## Subject: 2018 ISO LCR Study Criteria, Methodology and Assumptions

Submitted by	Company	Date Submitted
<i>Michele Kito 415-703-2197 Jaime Rose Gannon Simone Brant</i>	<i>Energy Division California Public Utilities Commission</i>	<i>November 14, 2017</i>

The CPUC Staff appreciate the opportunity to comment on the California Independent System Operator (CAISO) Draft Manual, 2018 Local Capacity Area Technical Study and the October 31, 2016 presentation entitled, “2018 ISO LCR Study Criteria, Methodology, and Assumptions.” In summary, Energy Division staff believes that:

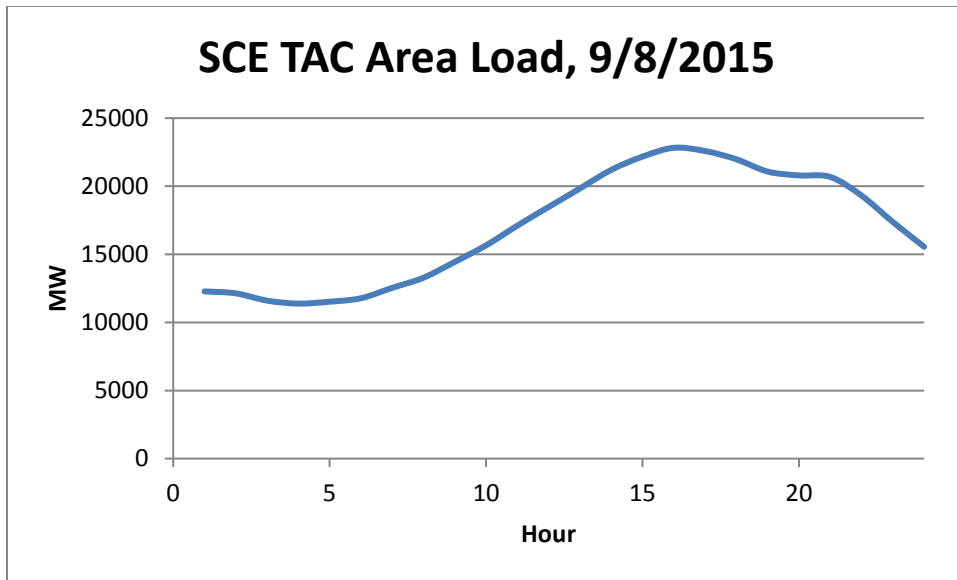
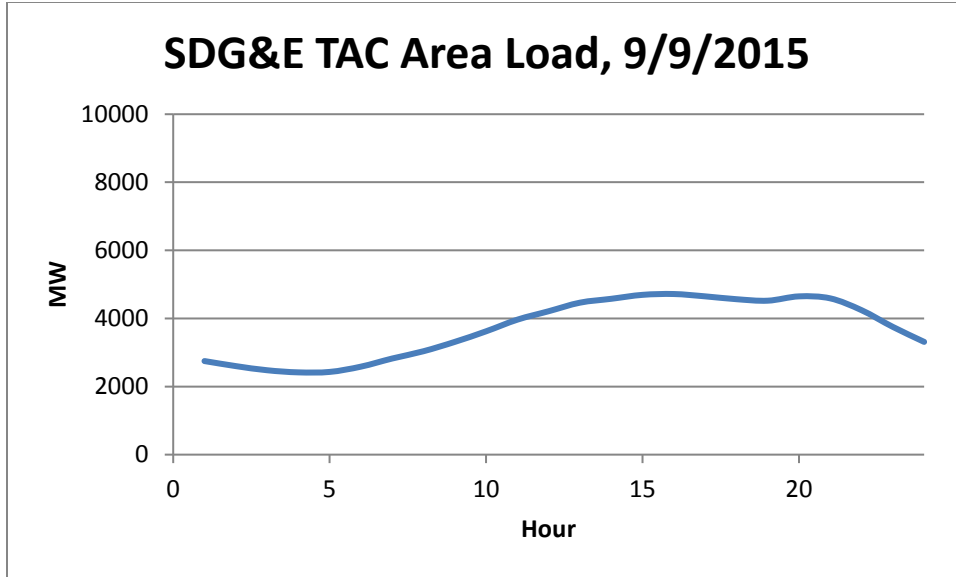
Energy Division staff finds the CAISO’s methodology, of adding back in all of the behind-the-meter generation (i.e. 254 MW for SDG&E and 733 MW for SCE for 2018) to the CEC’s base case forecast to be flawed as it overstates the loads in these areas. CAISO’s methodology is flawed because it does not take into consideration that consumption loads decline by 6 pm and, therefore, adding back in behind the meter generation to the 4 pm peak will result in a higher load than will be seen at the 6 pm hour. This is illustrated in the figures below.

That is, for the SCE TAC area, if 650 MW are added back in at 4 pm, this will overstate the sales load at both the 4 pm and certainly the 6 pm hour. Moreover, the CAISO’s peak shift adjustment is also problematic for the combined area, where the peak is likely to be driven by the SCE area. In sum, given the shape of these sales load curves, we believe that CAISO’s peak shift adjustment is likely to be flawed.

Consequently, Energy Division staff recommends that the peak shift analysis be considered only as a scenario, and that CAISO should conduct a study with only the CEC *adopted* forecast and with the assumption that Aliso Canyon is operational (to ensure comparability and to ensure that the CPUC is able to adopt LCR needs if Aliso Canyon is operational, without the peak-shift *scenario*, if appropriate).
